International Business Machines Corporation

May 18, 1979

Joseph M. Hendrie
Director
Nuclear Regulatory Commission
Malomic Building
1717 H Street NW
Washington, D.C. 20555

While watching the Three Mile Island, 3MI, debacle on television I was struck with the appearance of the island. It appears that 3MI is a comparatively flat, low-lying island situated in the middle of a large river, and probably comprised of alluvial sands and gravels. The geomorphology literature attests to the fact that this is the sort of topography that gets redistributed during the really extreme, say 1/1,000 or 1/10,000 year flood events. This raises two obvious questions, first what happens to a nuclear power plant when it is submerged in flood waters, and second what is the flood risk at the 3MI site?

SUSQUEHANNA RIVER AT HARRISBURG, PA.
1891 - 1977

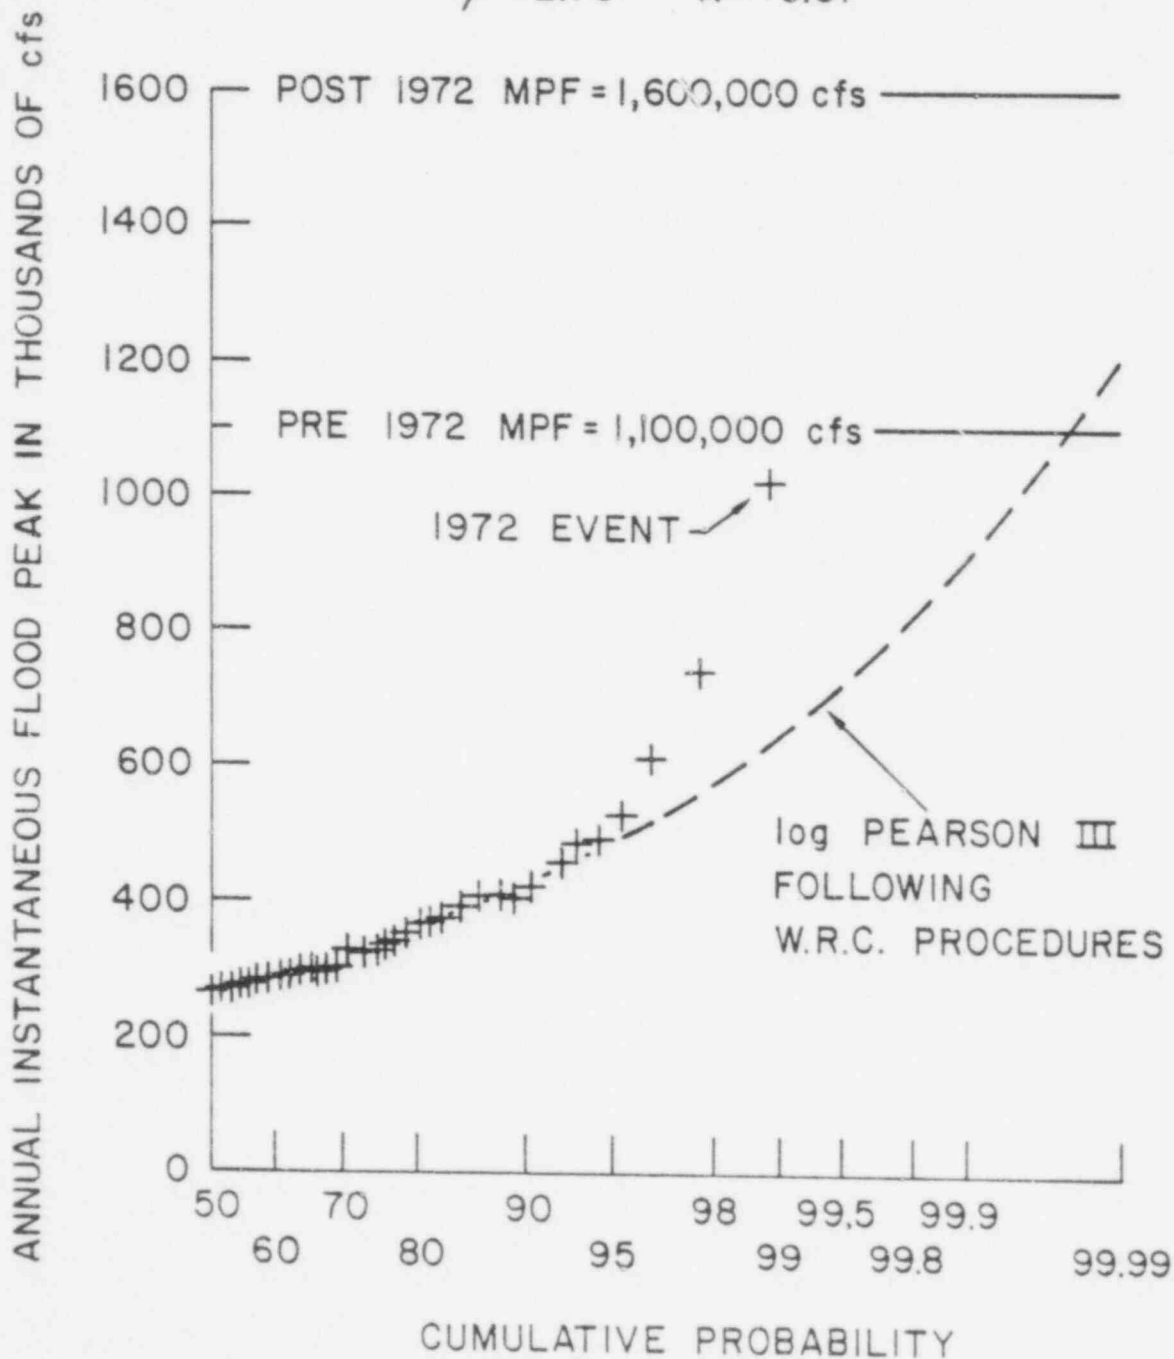
To evaluate the second of the above questions I have investigated the Susquehanna river data base, and asked a few questions here and there. There are 87 years of streamflow measurements for the Susquehanna river at Harrisburg, a fortunate circumstance as this is only a little upstream of the 3MI site. The highest instantaneous flow for each year can be obtained from the published records, ranked, and plotted on cumulative probability paper (see Figure 1). A log. Pearson III curve following the official U.S. Water Resources Council guidelines (Bulletin 17a) has also been shown on the figure. One might feel happier with this flood risk estimate (the fitted curve) if the procedures were not known to be totally fallacious.

The original design for the 3MI site estimated that "the maximum possible flood", MPF, for the site was 1.1 million cfs (cubic feet per second). In 1972 hurricane Agnes arrived and subsequently a new MPF of 1.6 million cfs. Will the next big event raise the MPF another 45%? Do you know the mechanics of how such estimates are made? From the name it sounds like the procedure developed in the thirties that has little to do with science, nothing to do with

The risk of flooding does seem to be rather high for the 3MI site. One can't help but wonder why 3MI was selected, when the use of Hill Island would have removed this consideration. It is understood that a levee has been constructed that is meant to maintain the integrity of the 3MI site from an event the size of the latest estimated MPF. All well and good, but levees have been known to fail, and MPF's are not decreed by God, but estimated by fallible man. Are the geophysical hazards at other nuclear plants of similar magnitude, and are risk evaluations, as at 3MI, always based upon a single number?
